S. I. No. M20-39

Date: 12-2-76

SERVICE INSTRUCTION**SUBJECT: INTERIOR DOOR HANDLE REPLACEMENT**

FIGURE 1

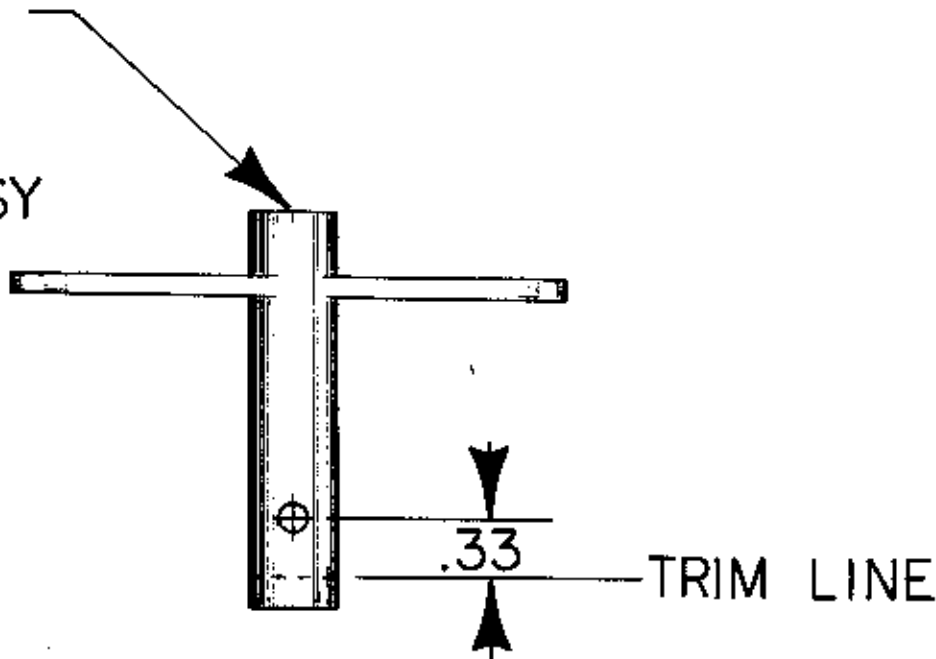
2. Trim handle shaft $.30 + .030$ from center of roll pin hole. See Figure 1.

FIGURE 2

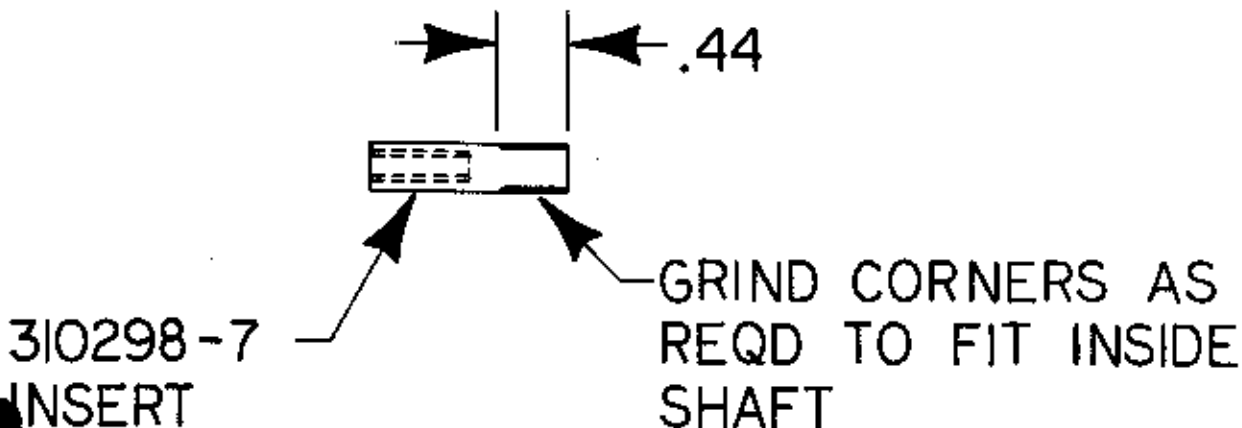
3. Grind corners on 310298-7 insert as required to fit inside handle shaft. See Figure 2.
4. Position 310298-7 insert in handle shaft with respect to levers as shown in Figure 3. Threaded end of insert to protrude .62 from end of shaft. Tungsten inert gas arc weld insert to shaft.

FIGURE 3

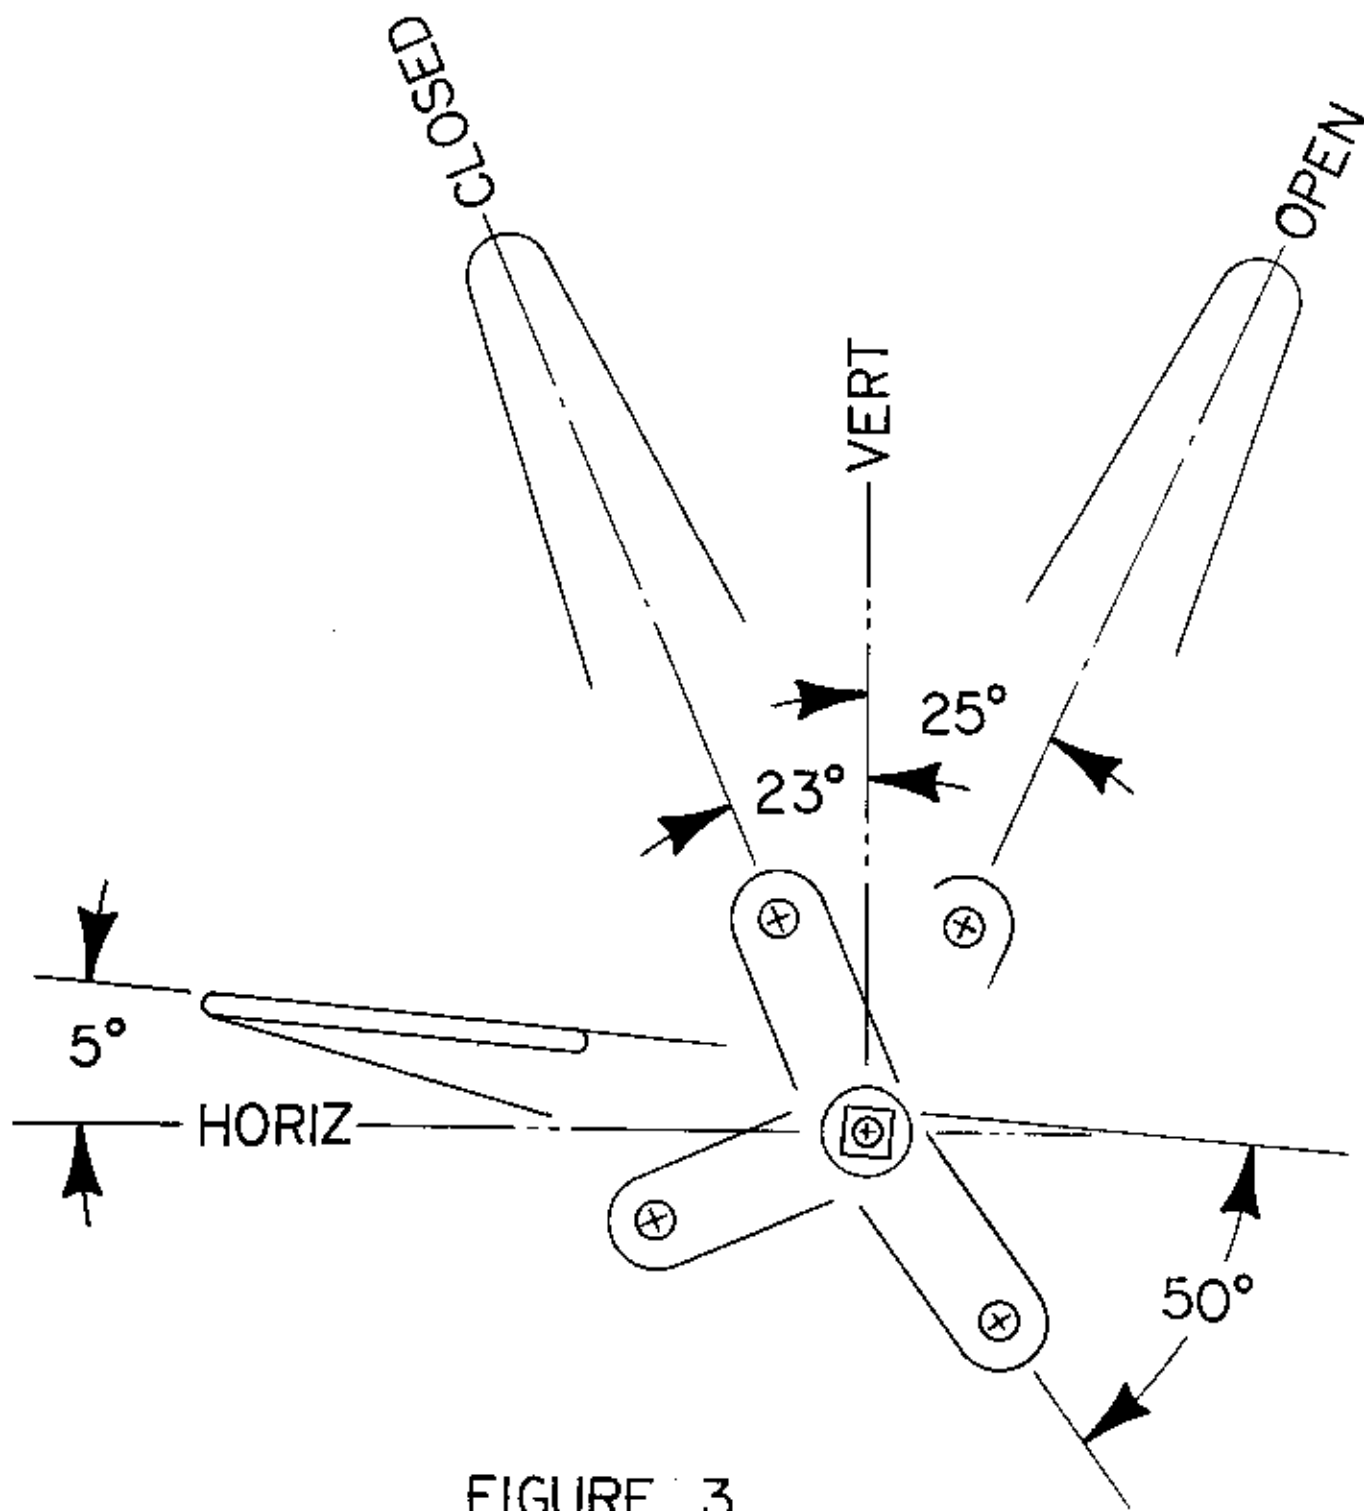
NOTE: Handle in closed position will be 5° above a horizontal plane. Owner Option - Disregard insert angular position; position handle to satisfy individual taste.
